CITY OF KELOWNA

MEMORANDUM

Date: March 23, 2020
File No.: Z20-0021
To: Suburban and Rural Planning (AK)
From: Development Engineering Manager (JK)
Subject: 2980 Gallagher Rd - Kirschner Mountain Phase 6 – A1 to RH3

WORKS AND SERVICES REQUIREMENTS

SHEET TITLE
SITE PLAN

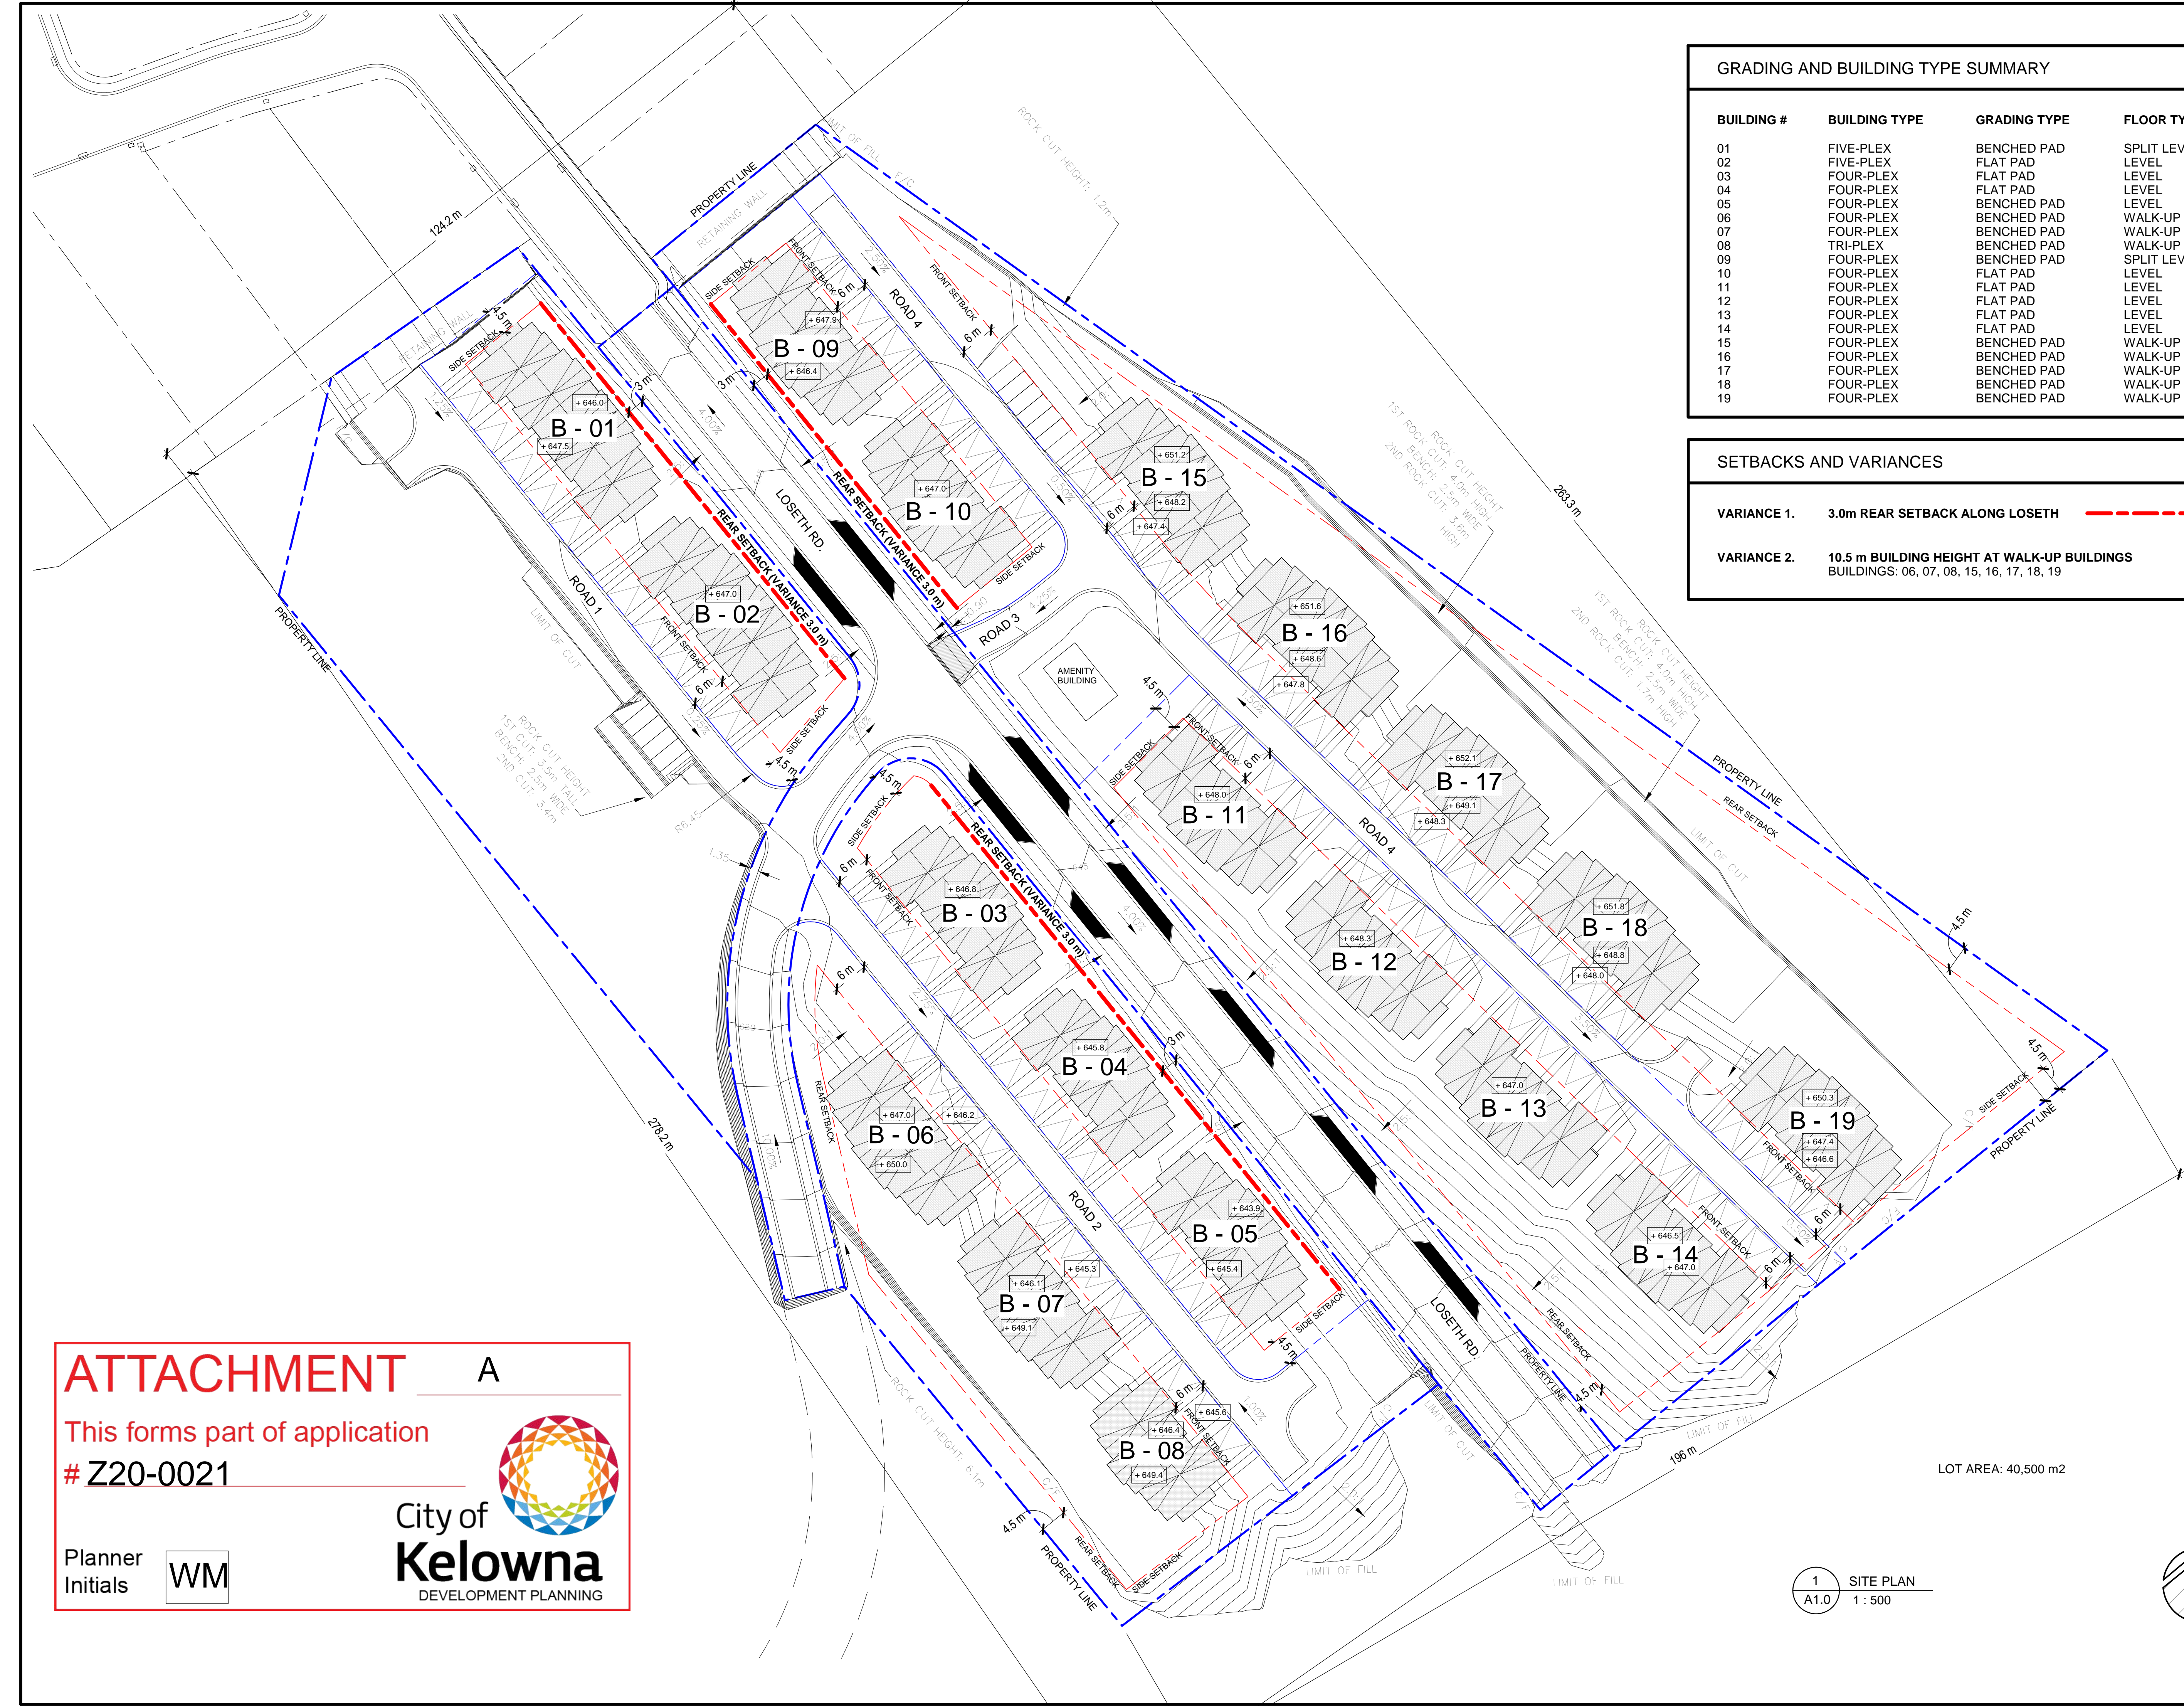
- a) All retaining walls are to be contained within privately-owned lots.
- b) As Loseth Rd is classified as a Major Collector, waste collection vehicles cannot back onto Loseth Rd. Please provide on-site turning movements showing an MSU vehicle turning on site without having to back onto Loseth Rd.

- a) Clarify the proposed legal protections (e.g., no-build/no-disturb covenants) for the 2H:1V fill slopes outside of the proposed property lines.
